**LEBANON PLANNING BOARD
JUNE 13, 2022 - 6:30 PM
COUNCIL CHAMBERS, CITY HALL OR
REMOTE VIA VIRTUAL PLATFORM
LEBANONNH.GOV/LIVE**

**Recreo, LLC,
2 Mascoma Street
(Tax Map 91, Lots 254),
Zoned LD
PB2022-17-SPR**

2 MASCOMA STREET REDEVELOPMENT

Site Plan Review for a proposed phased expansion of the DHMC Outpatient Surgery Center

C2.1
SHEET 9 OF 16

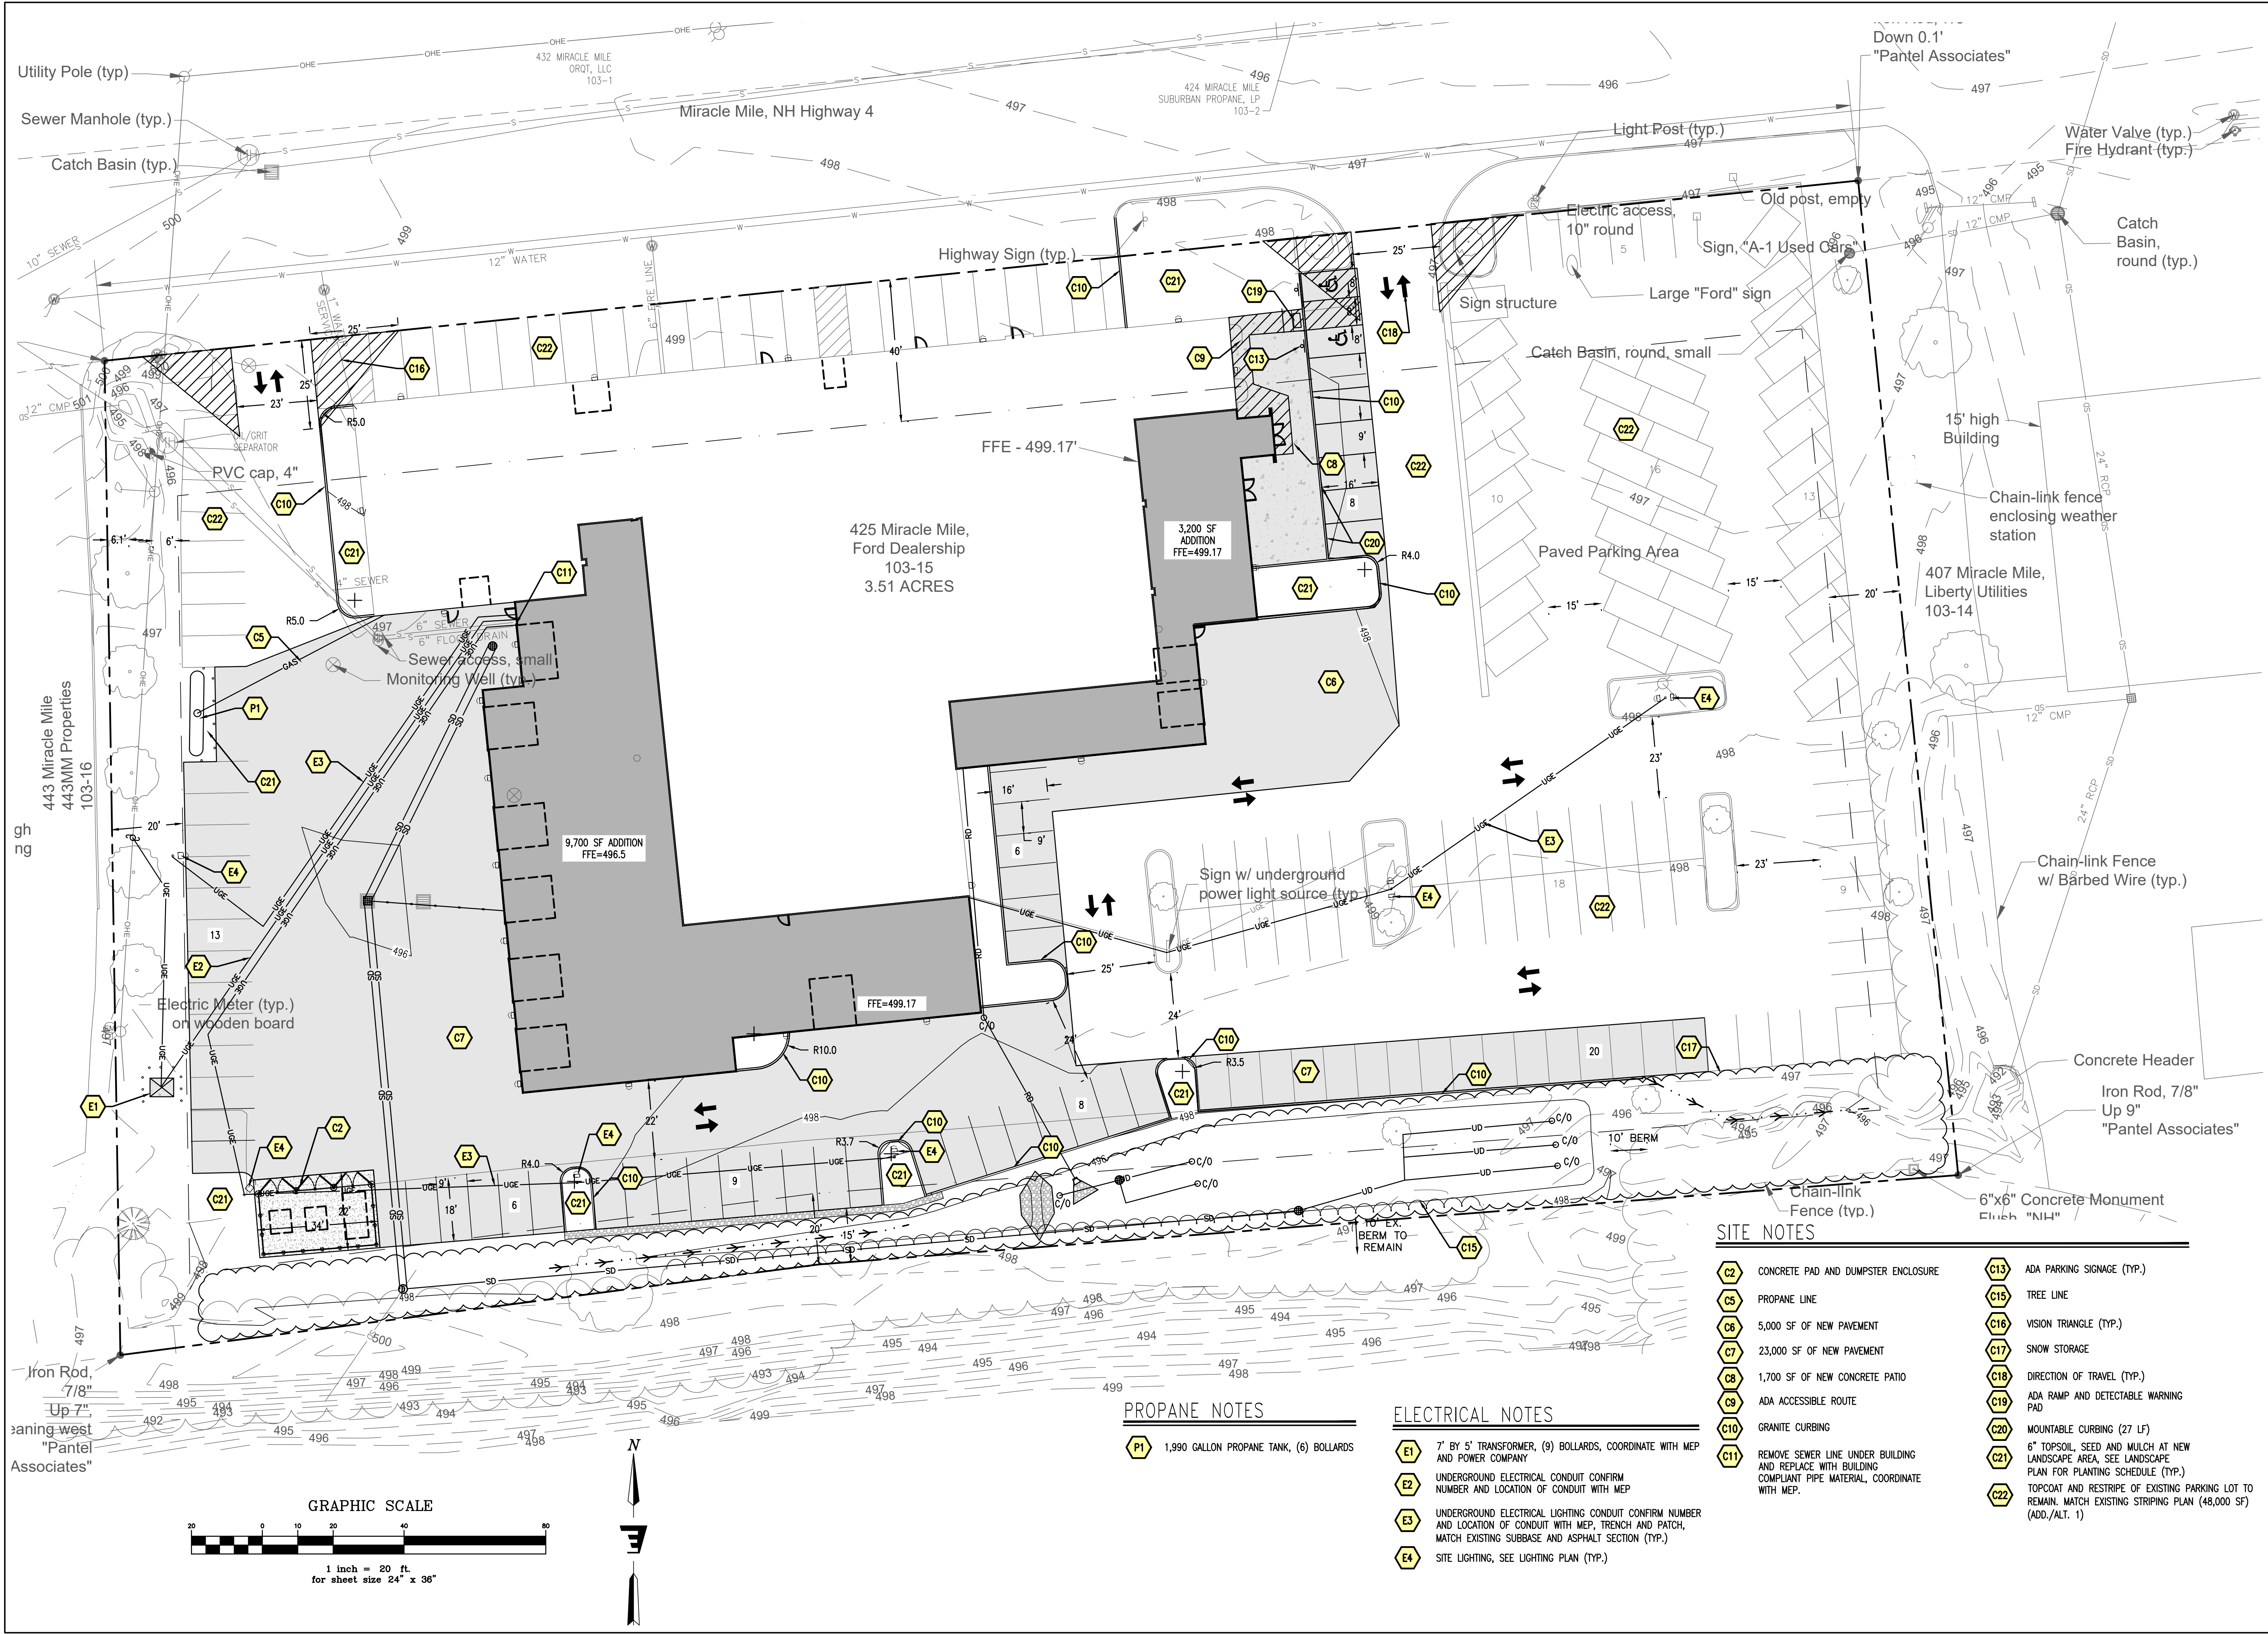
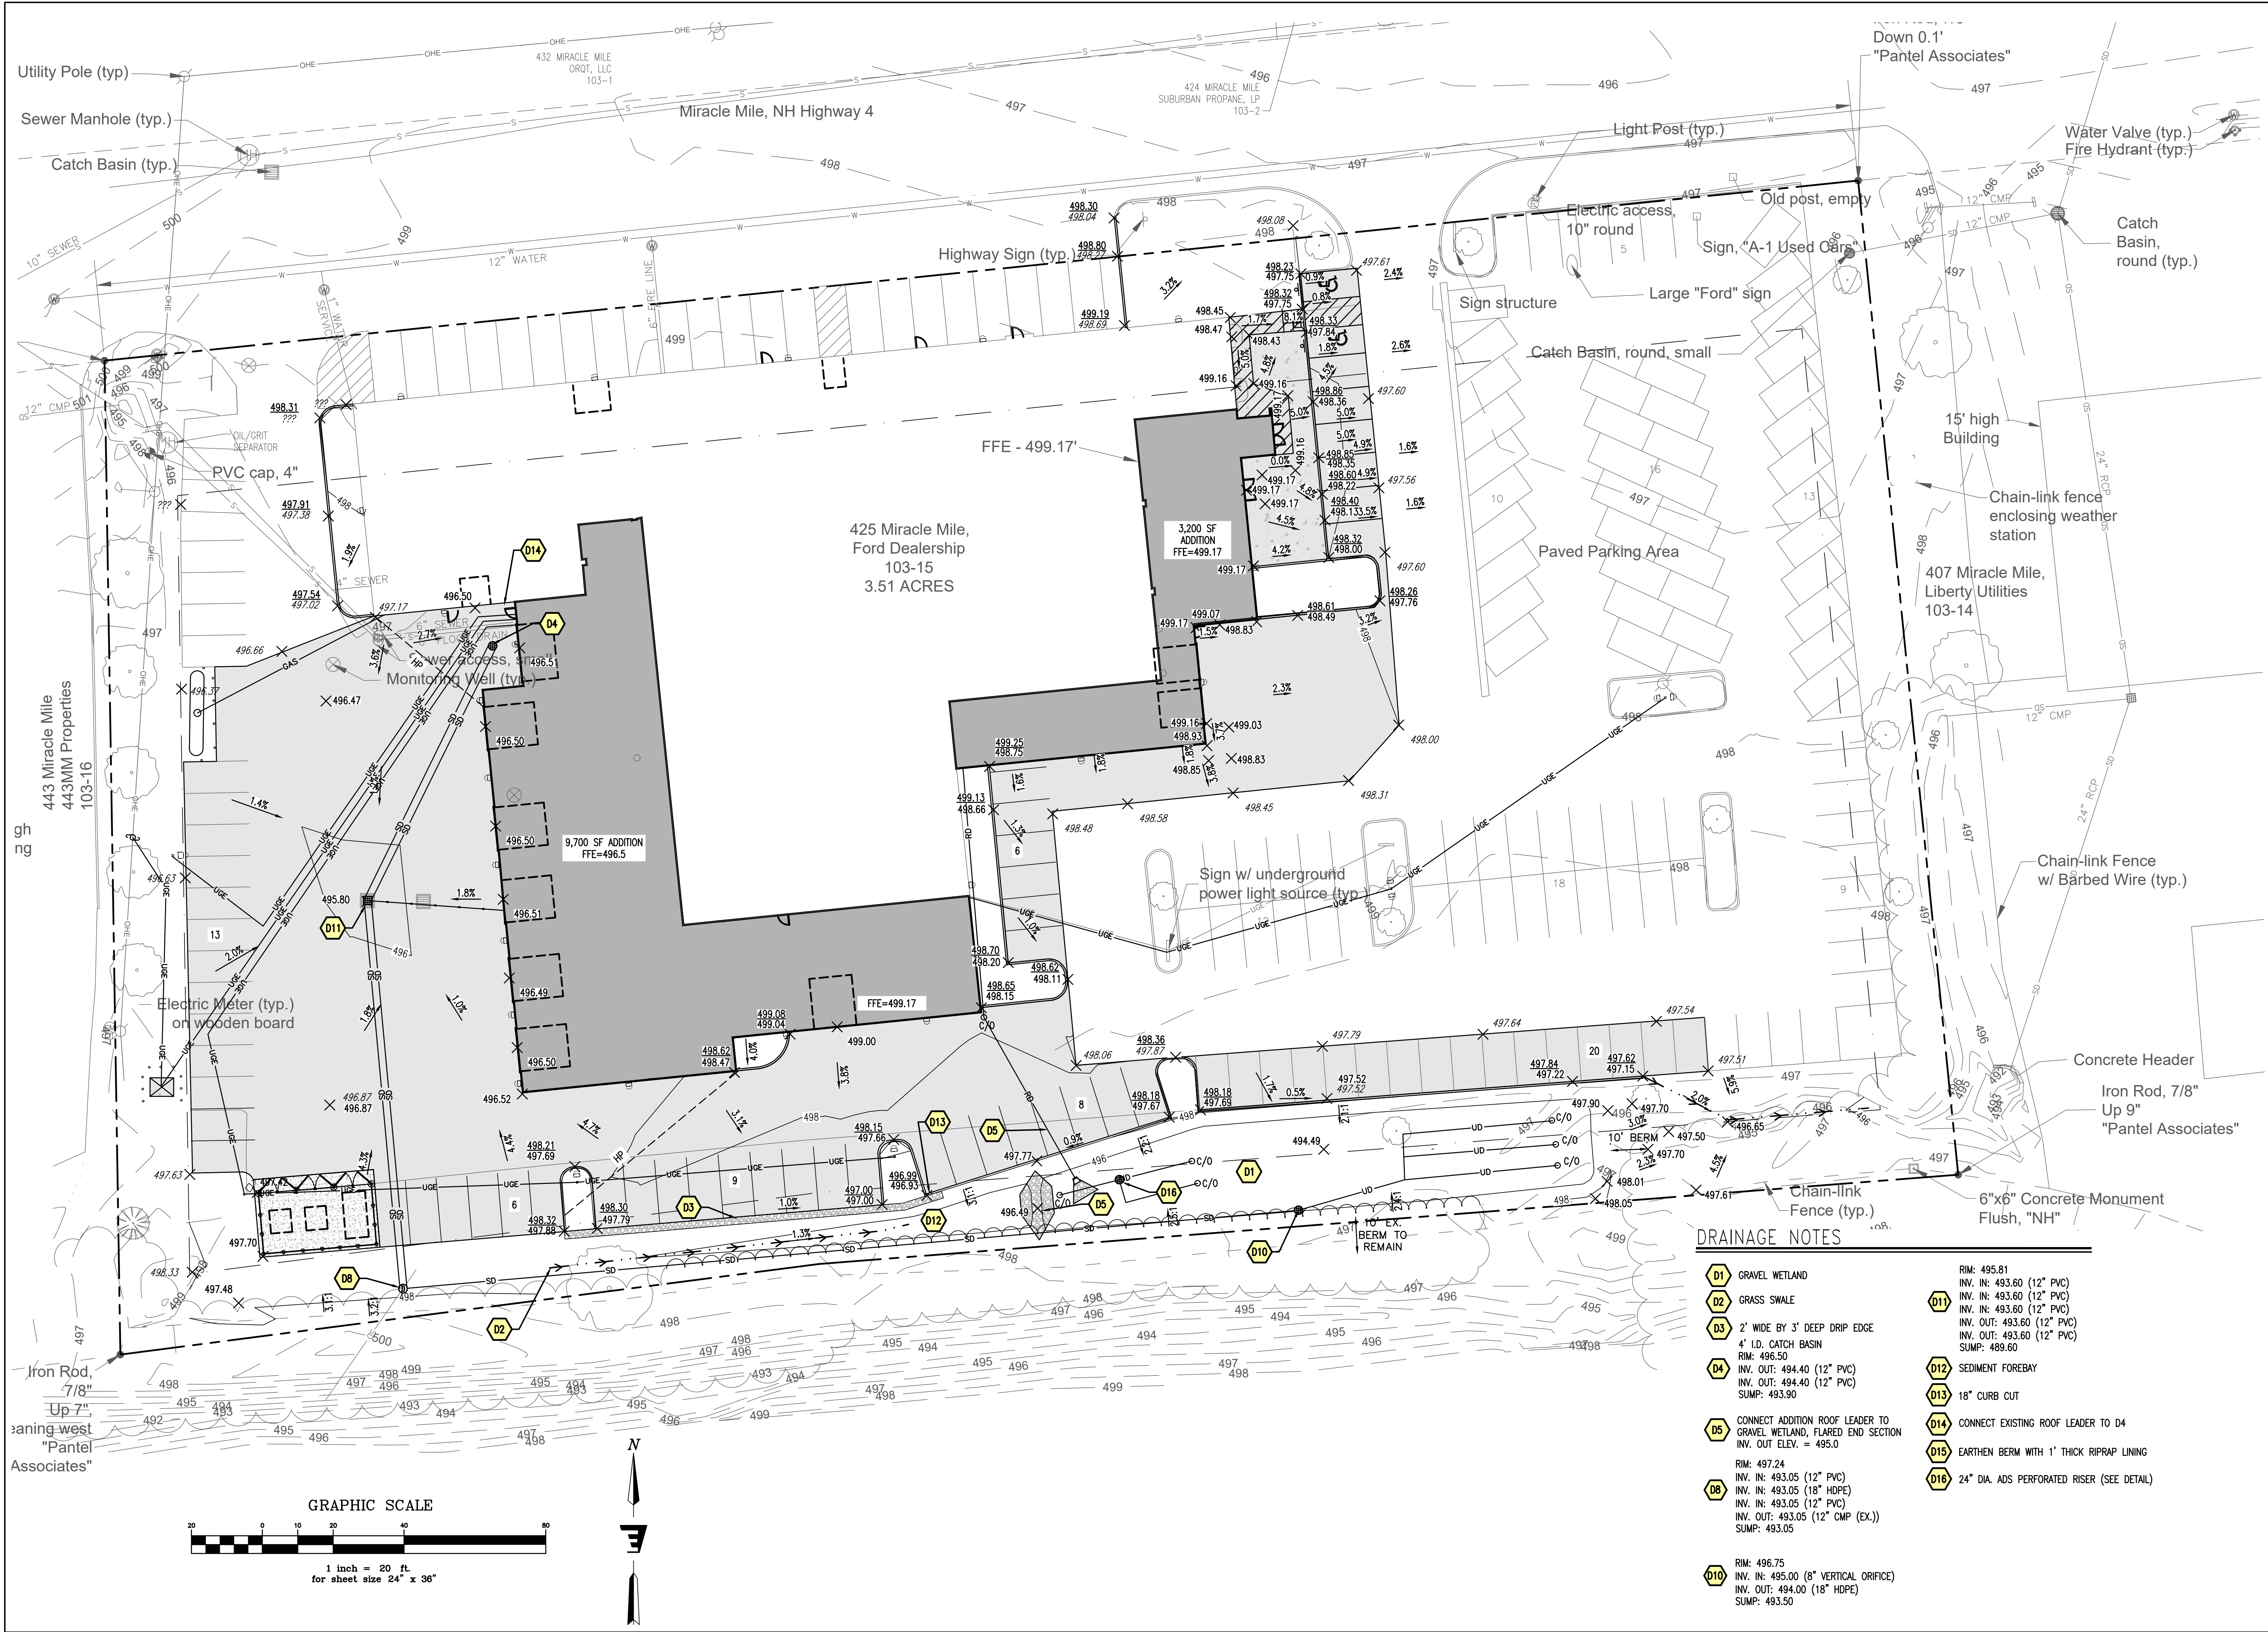
Section 9.2.B further provides that a change shall be deemed to be a minor alteration only if all of the following apply:

Stamp	
Date	Description
4/28/2022	FIELD CHANGES
5/11/2022	REMOVE 2 ADA SPACES
